MILITARY SPECIFICATION

MODULES, STANDARD ELECTRONIC

MEMORY, RANDOM ACCESS, KEY CODE ZJS

This amendment forms a part of Military Specification MIL-M-28787/302A(EC), dated 10 July 1981, and is approved for use by the Naval Electronic Systems Command, Department of the Navy, and is available for use by all Departments and Agencies of the Department of Defense.

FIGURE 8. Input clamp diode voltage test circuit for table V.

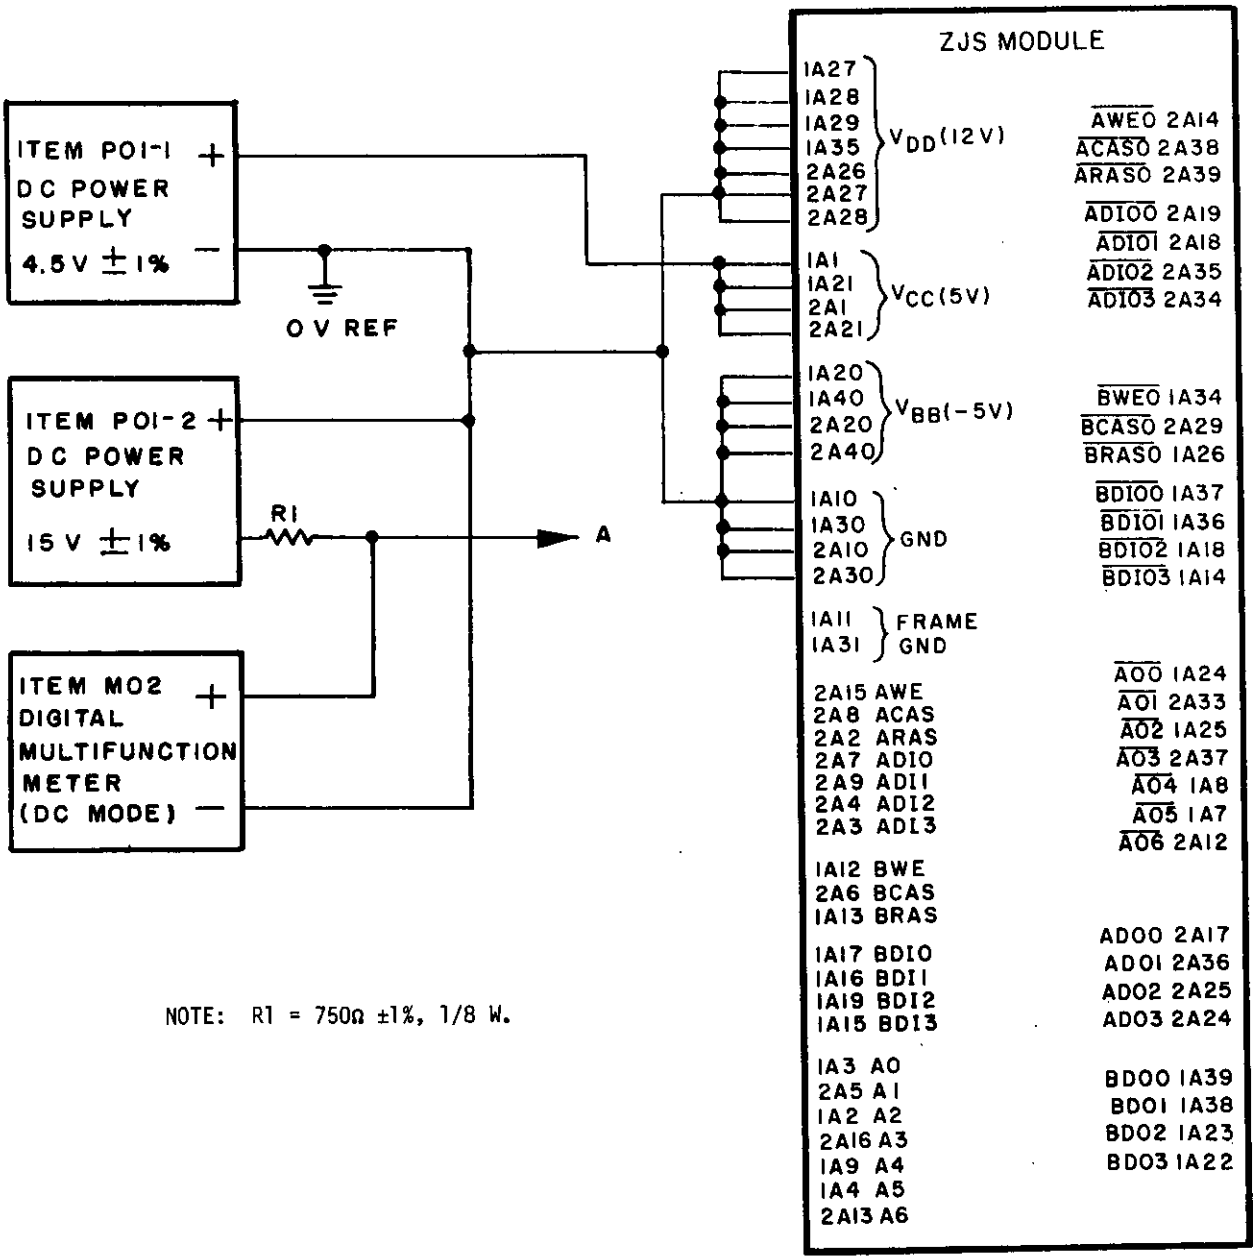
FIGURE 8: Delete and substitute new figure 8 as printed on page 4 of this amendment.

NOTE: R1 = 750Ω ±1%, 1/8 W.

FIGURE 12. Output voltage (low-level and high-level) test circuit for table IX.

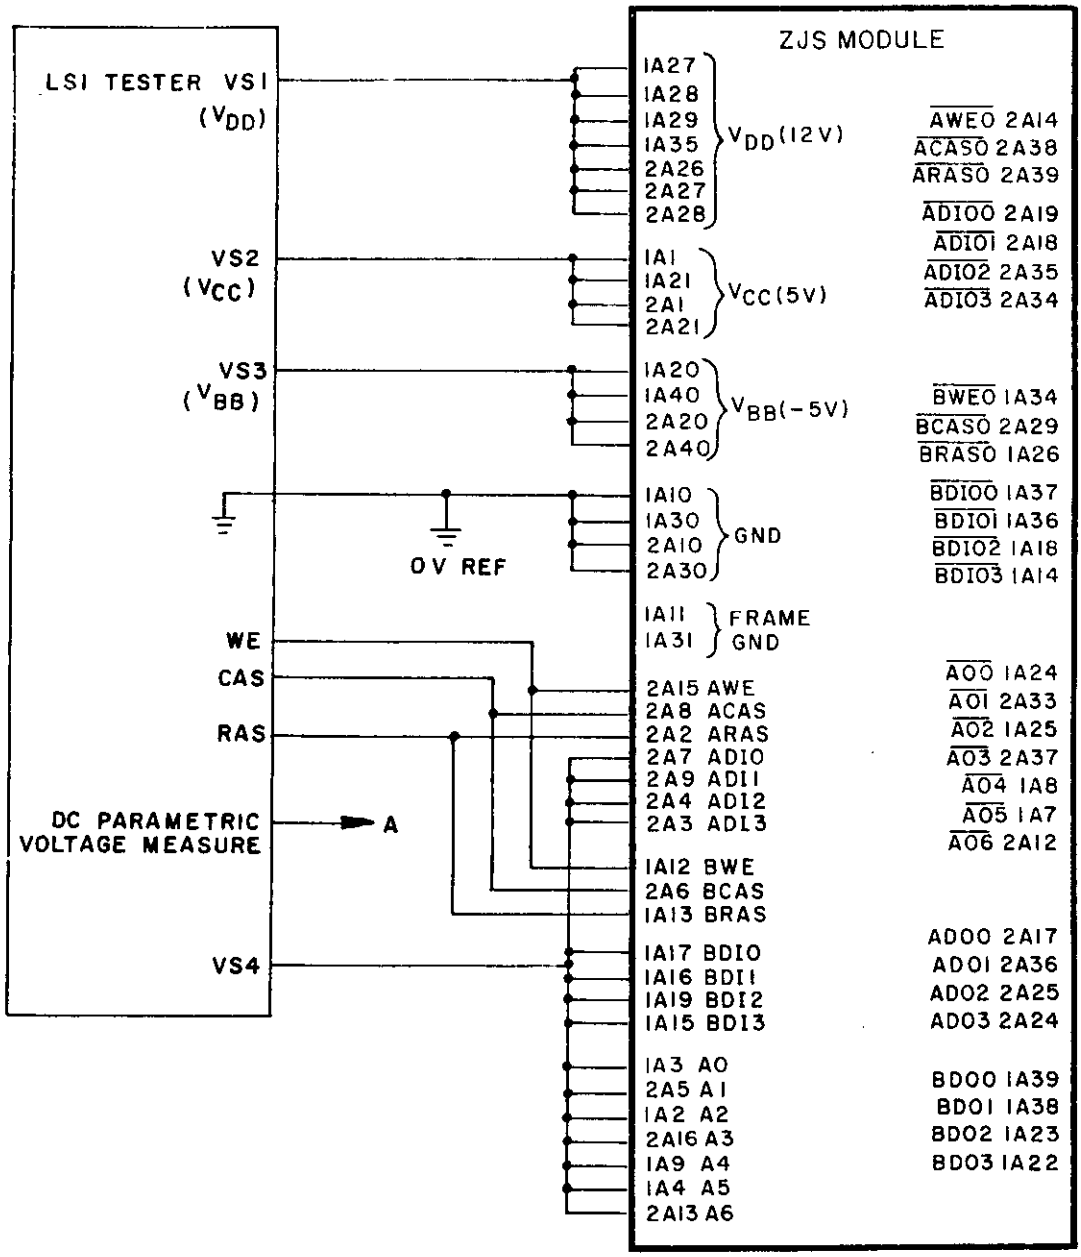
FIGURE 12: Delete and substitute new figure 12 as printed on page 5 of this amendment.

NOTES:
1. All tester leads to be of minimum length.
2. Input conditions are found in table X for test conditions K1-K8 and table XI for test conditions L1-L8.
3. Load outputs per figure 14.

FIGURE 18. Dynamic functional test circuit for table XIII.

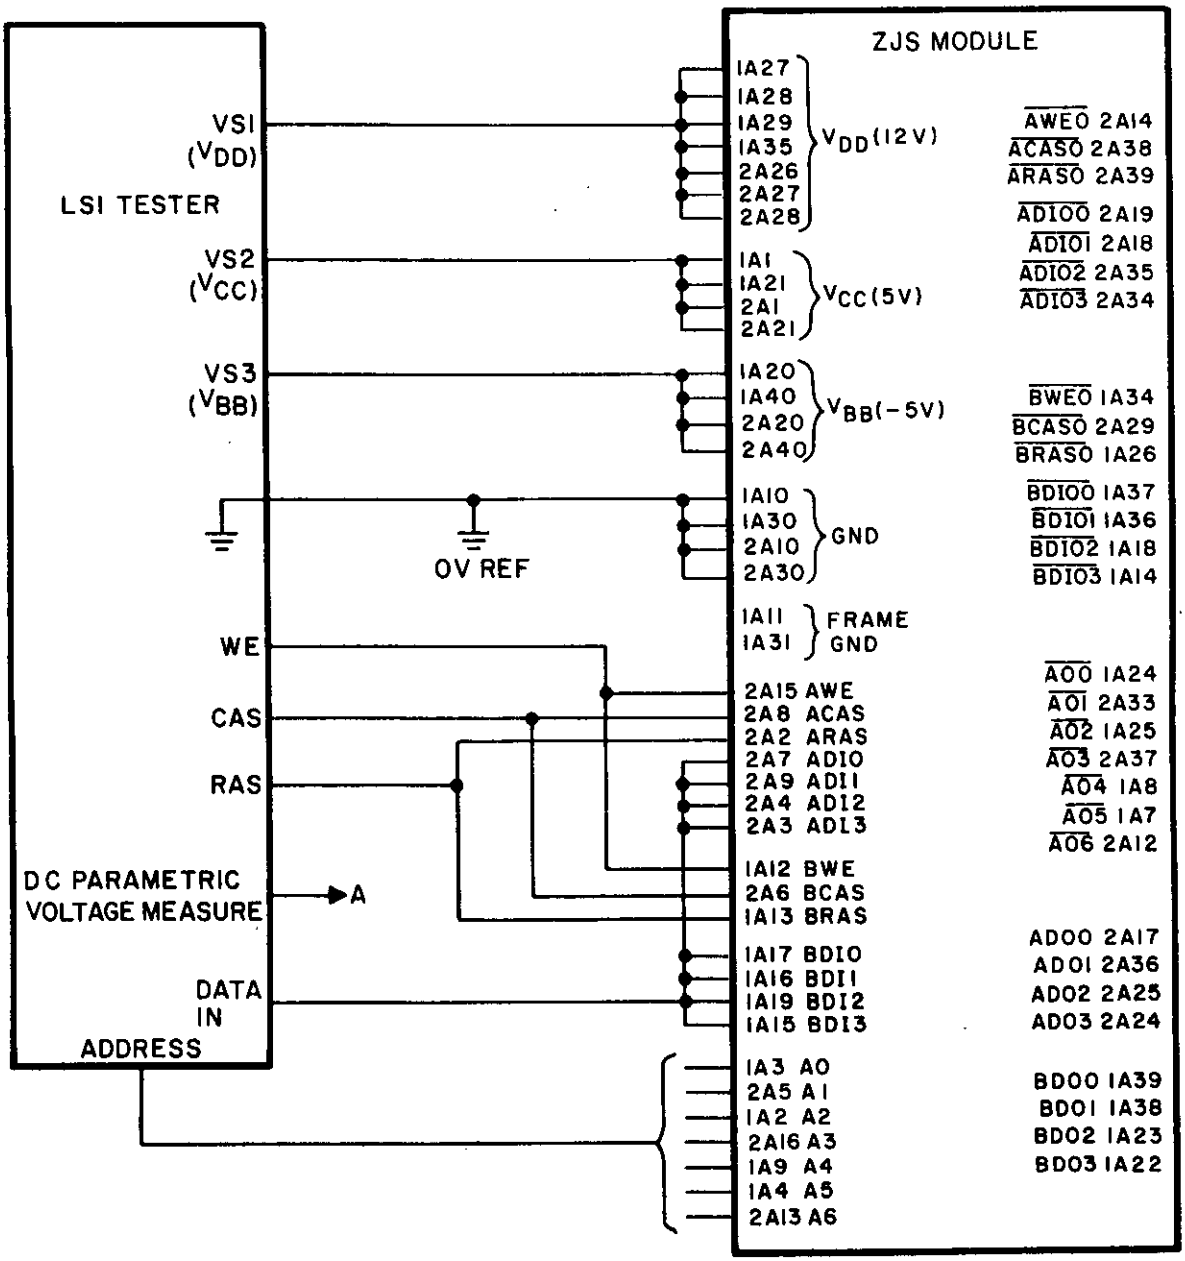
FIGURE 18: Delete and substitute new figure 18 as printed on page 6 of this amendment.

NOTES:
1. All tester leads to be 2 inches (50.8 mm) maximum length.
2. Load each output per figure 14.
